AMENDMENTS TO THE DRAWINGS

The attached replacement sheet (1/5) of drawings includes the following changes:

Figure 1

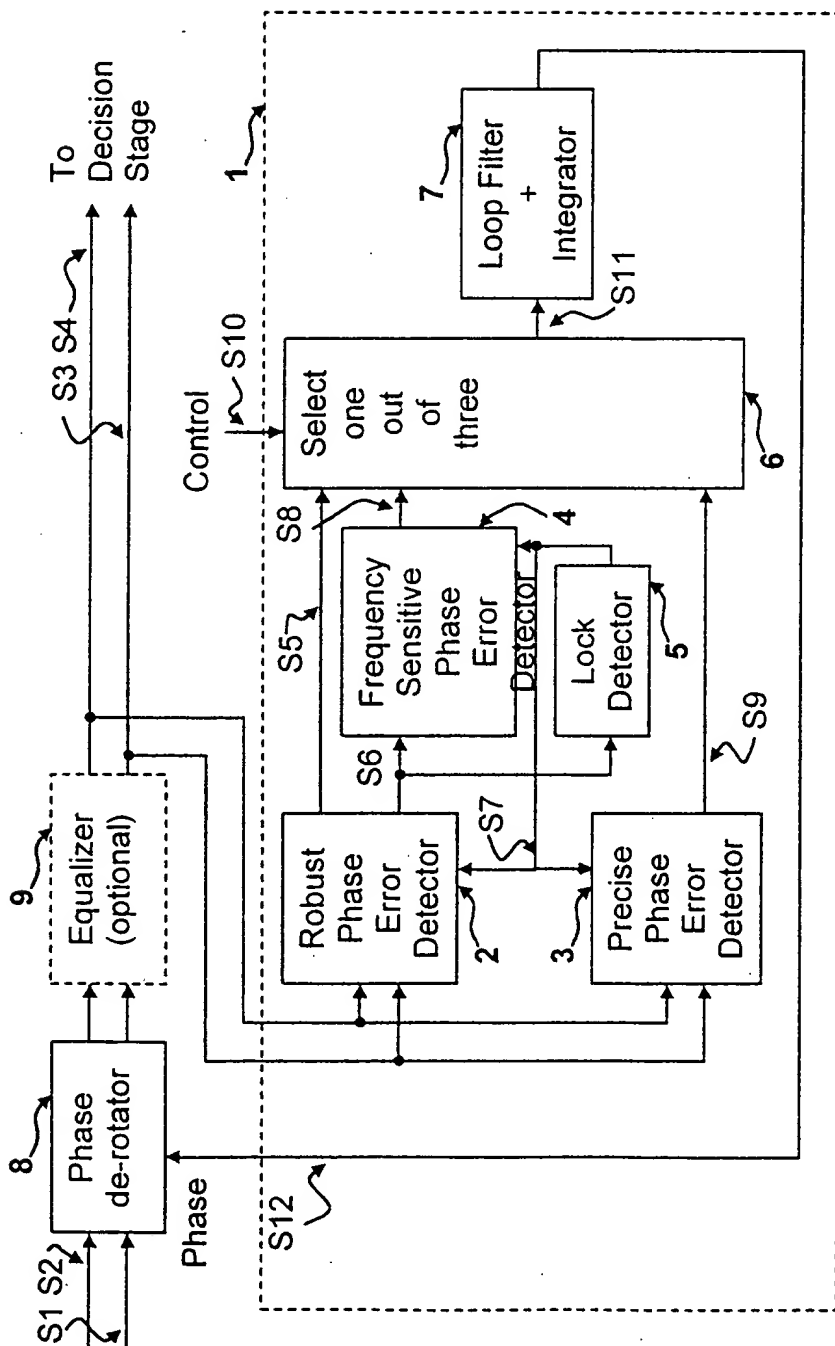
In Figure 1, please connect signal S7 (output by Lock Detector 5) to the Precise Phase Error Detector 3 as shown.
